Addendum No. 1 to IFB 14-54

To: All Parties on Record with the City of Somerville as Holding IFB 14-54,
Selective Demolition at Somerville High School

ADDENDUM NO.1

Repairs to Somerville
High School
Auditorium, Kitchen
and Cafeteria

AD103

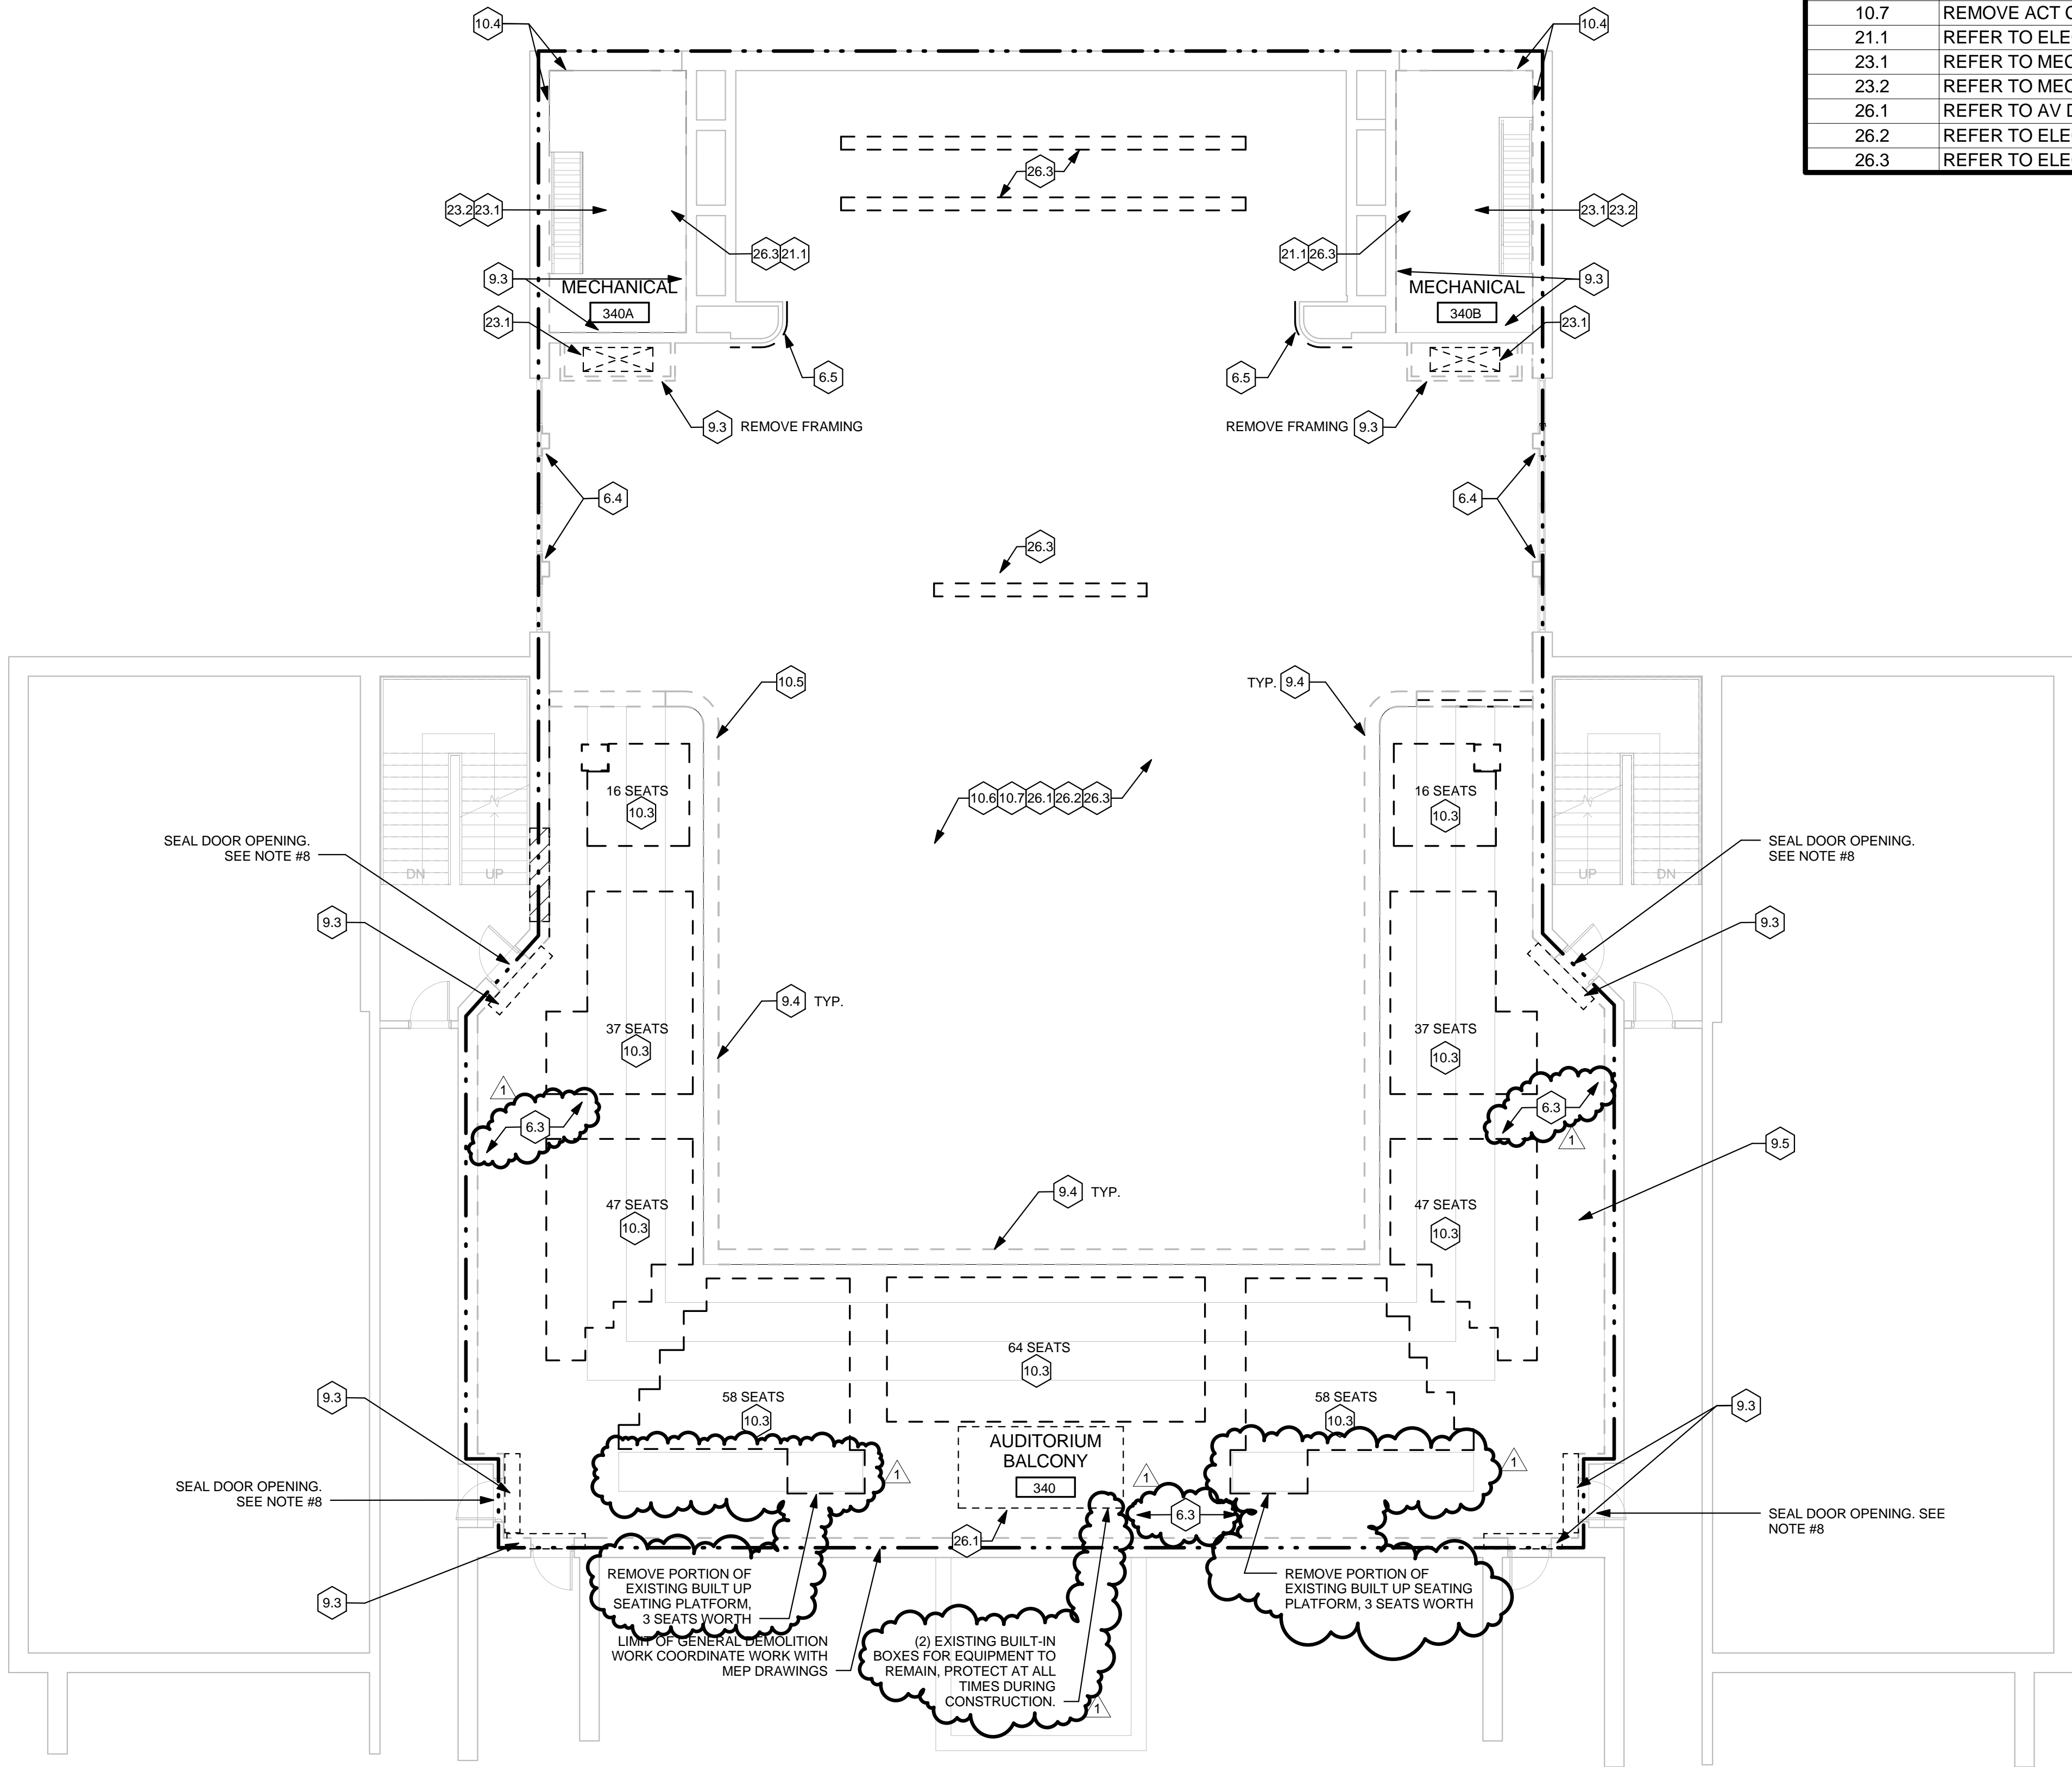
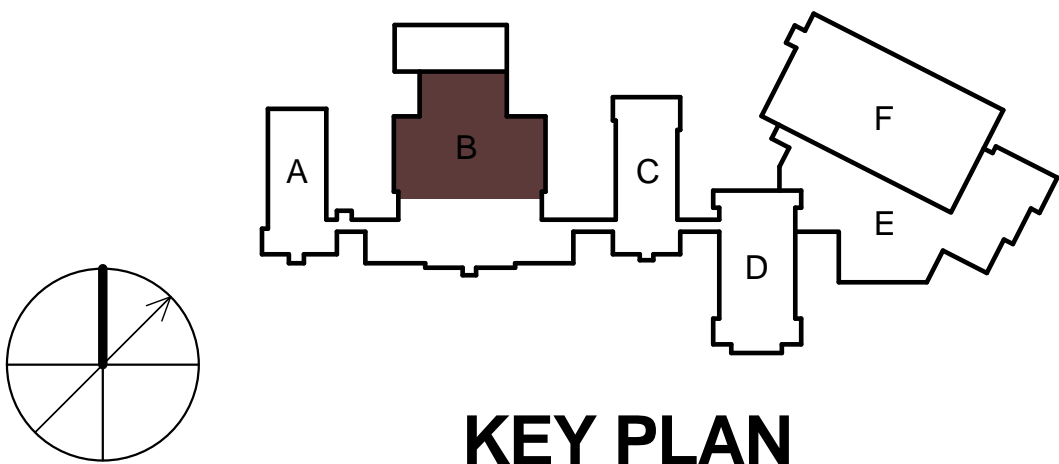
C. Drawing AD103 AUDITORIUM BALCONY DEMO FLOOR PLAN

1. AUDITORIUM 340, add plan note 6.3 to read,

“REMOVE HARDWOOD FLOOR SUBSTRATES AND SLEEPERS.”

2. AUDITORIUM 340, Revise demolition region of built up seating. Only 3 seat lengths of built up region on balcony to be demolished.

3. AUDITORIUM 340, Add note at back of balcony to read,

“(2) EXISTING BUILT-IN BOXES FOR EQUIPMENT TO REMAIN. PROTECT AT ALL TIMES DURING CONSTRUCTION.”

AD105

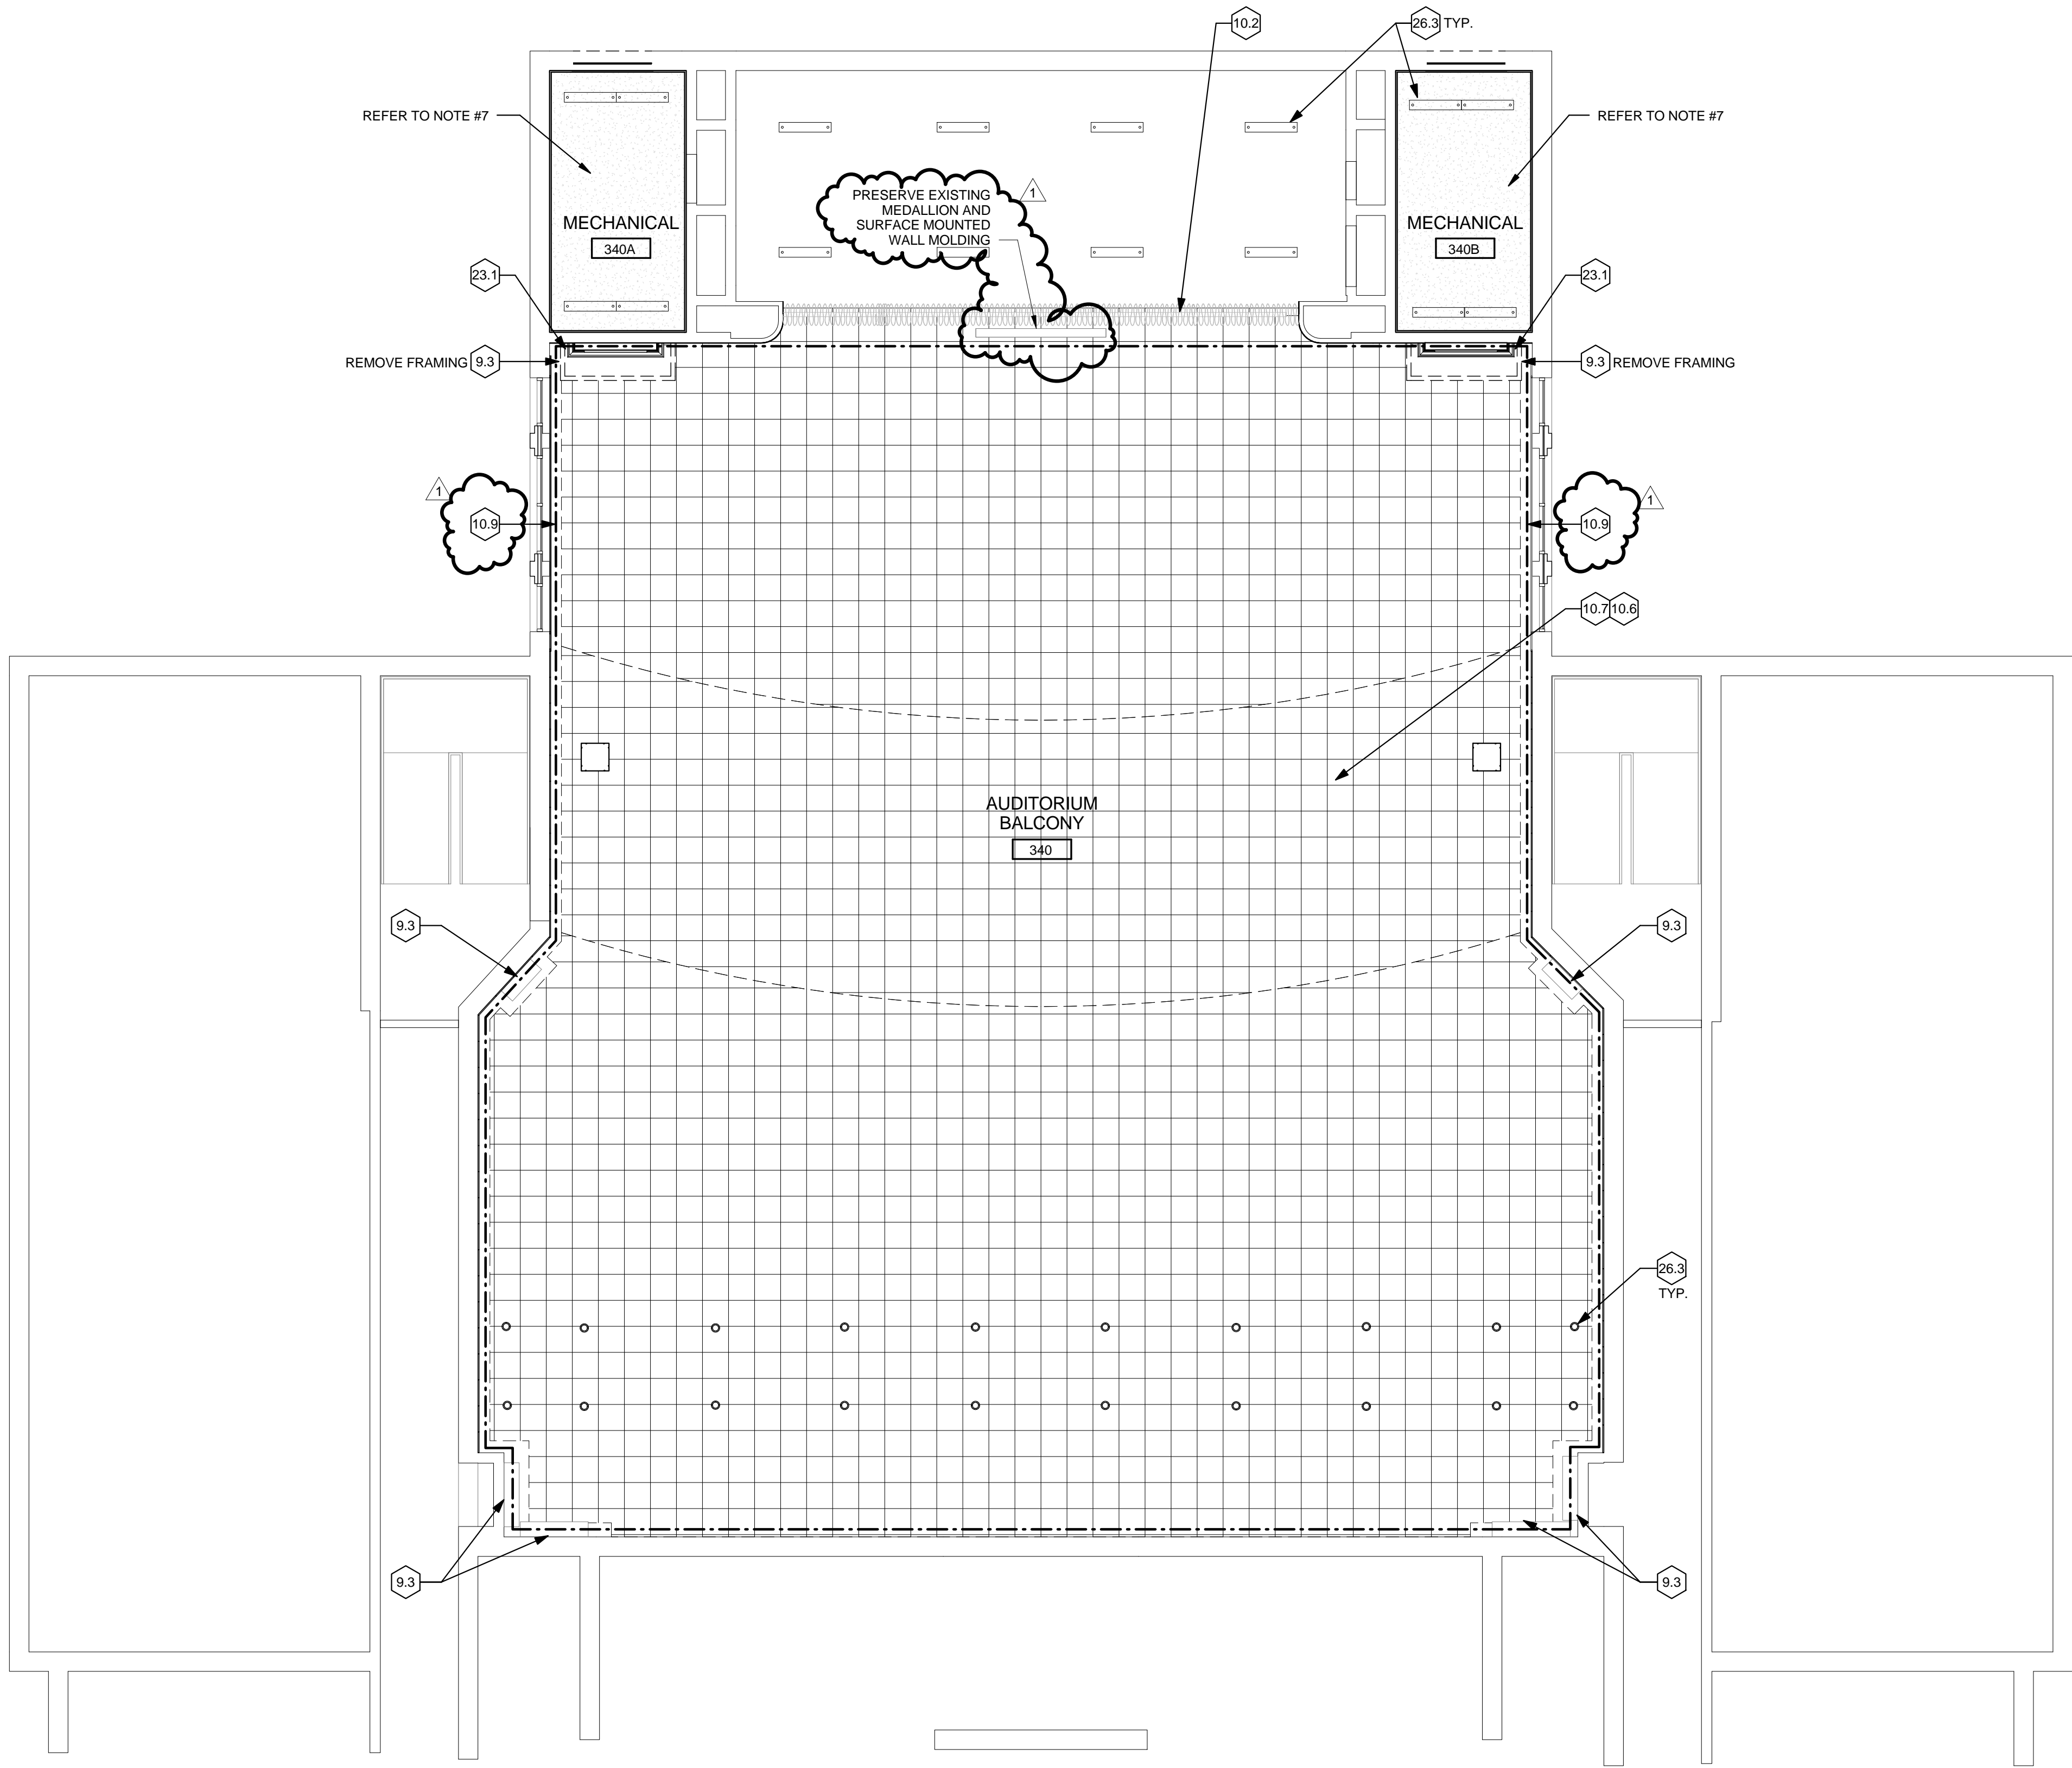
D. Drawings AD105 AUDITORIUM DEMO REFLECTED CEILING PLAN

1. AUDITORIUM 340, add plan note 10.9, to read,

“REMOVE PLASTER MOLDING AT PLASTER CEILING EDGE.”

2. AUDITORIUM 340, add note at stage front to read,

“PRESERVE AND PROTECT EXISTING PLASTER MEDALLION AND SURFACE MOUNTED WALL MOLDING.”
